Nomad

SERVICE BULLETIN

FLIGHT CONTROLS-FITMENT OF MASS BALANCE TO RUDDER TAB

NMD-27-3
Page 6 of 6

Figure 1 Fixing Mas Balance To Rudder Trim Tab

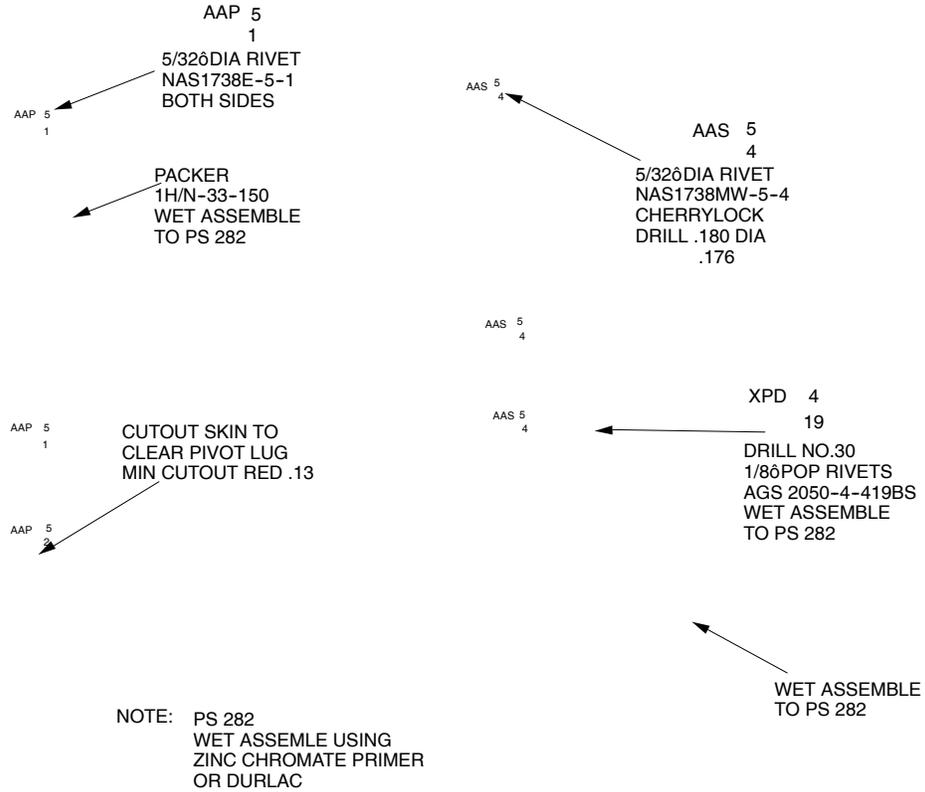
Remove and replace the pop rivets in the tab rib at WL 110 and replace with cherry rivet NAS1738E5-1 (8 places) and NAS1738ES 2 (2 places). Refer figure 1. Relieve the hinge, and skin at tab to obtain clearance for the pivot lug 2/N-33-177 per figure 1.

Locate the packer 1H/N-33-150 and the mass balance plate 1/N-33-178 on the bottom rib ensuring the pivot hole will be in line with the hinge centreline. Using the predrilled mass balance plate as a template, drill (.176/.180) the seven locations. The two rivet locations in the welded flange are to be filled with 1/8 pop rivets. Attach packer and mass balance by applying sealing compound PR1222 or equivalent and cherry lock rivet NAS1738MW5-4. Reidentify the trim tab as 3/N-33-150.

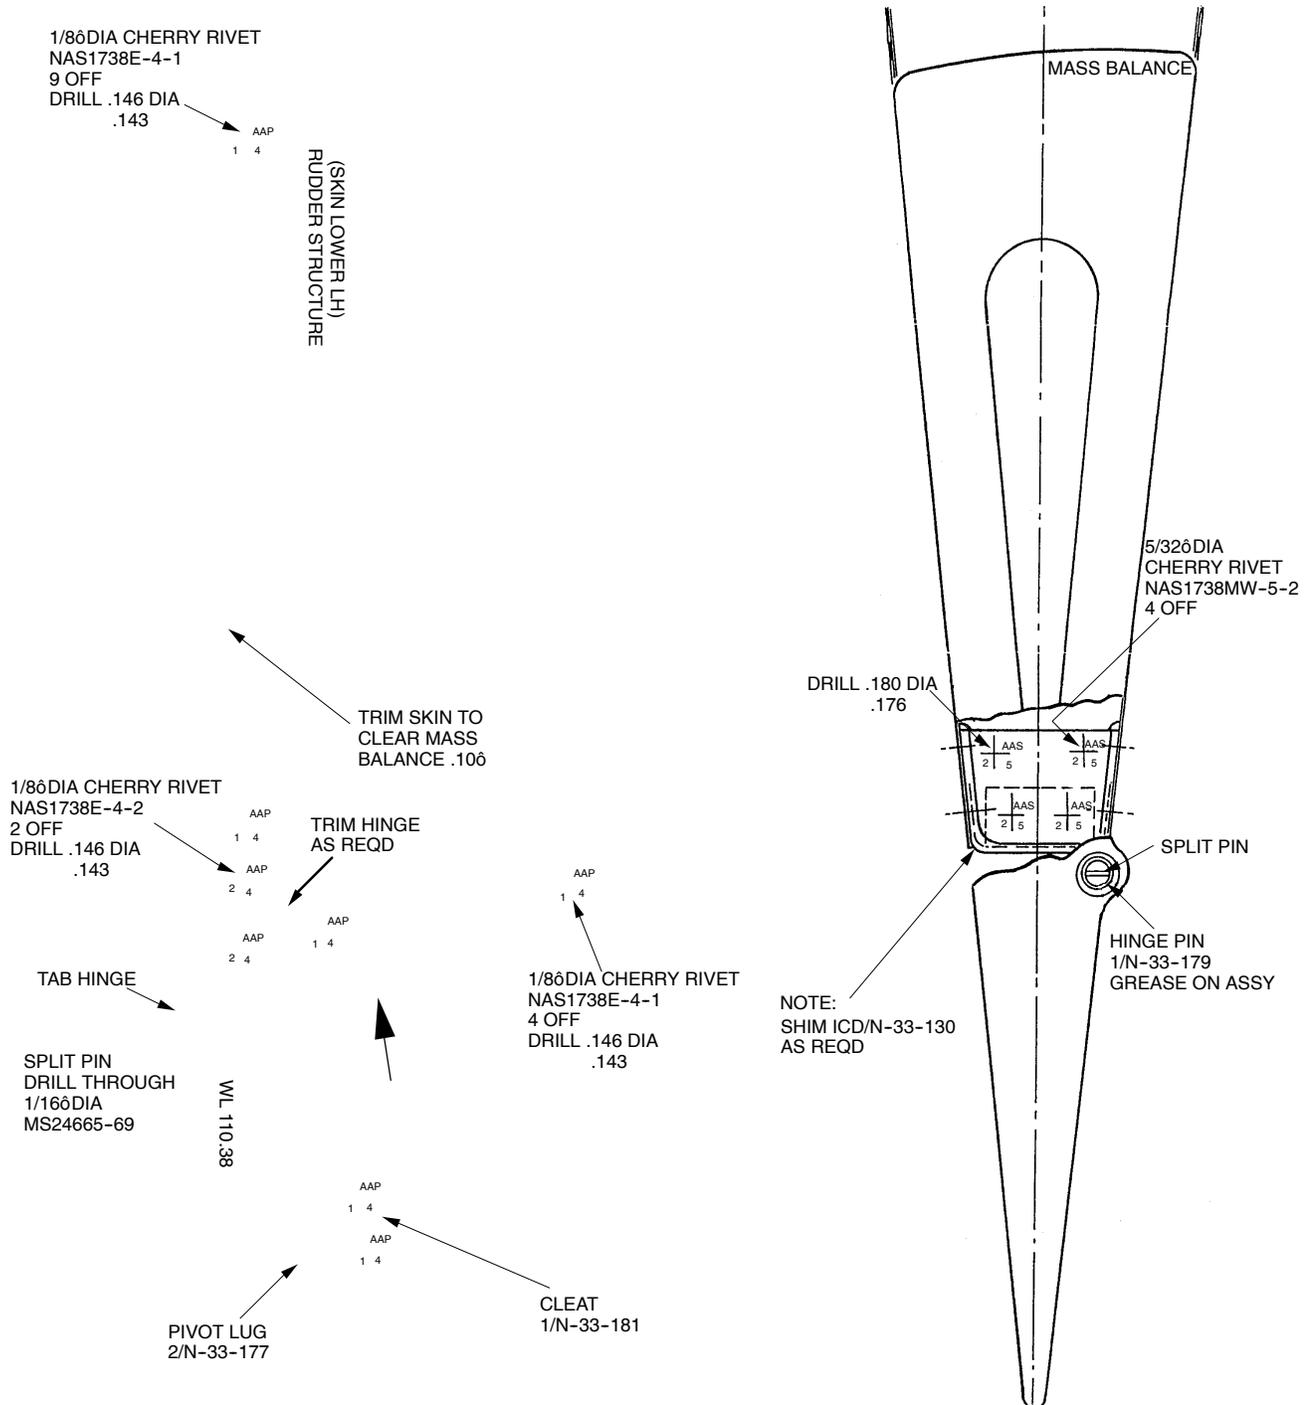
Remove 9 rivets from M rudder skin at WL110, plus 4 rivets from the vertical channel and lift skin to gain access. Remove and discard cleat 1BA/N-33-150. Fit the pivot 2/N-33-177 beneath the rib, trimming skin and hinge where necessary (refer fig. 2). Above the rib locate the cleat 1/N-33-181 picking up existing rivet locations and attach to the vertical channel using 2 each 1/8 cherry rivets NAS1738E4-1. Locate pivot lug 2/N-33-177 ensuring the threaded hole is in line with the hinge centreline and drilling 4 holes .176/.180 DIA per figure 2 and attach pivot lug with 5/32 cherry rivets NAS1738MW5-2. Shim each side between skin and pivot lug with shim ICD/N-33-130 as necessary. Replace skin using 1/8 cherry rivets NAS1738E4-1 (13 places) and NAS1738E4-2 (2 places) refer figure 2. The side skins are to be relieved by approx. .125" to give clearance between the mass balance and rudder.
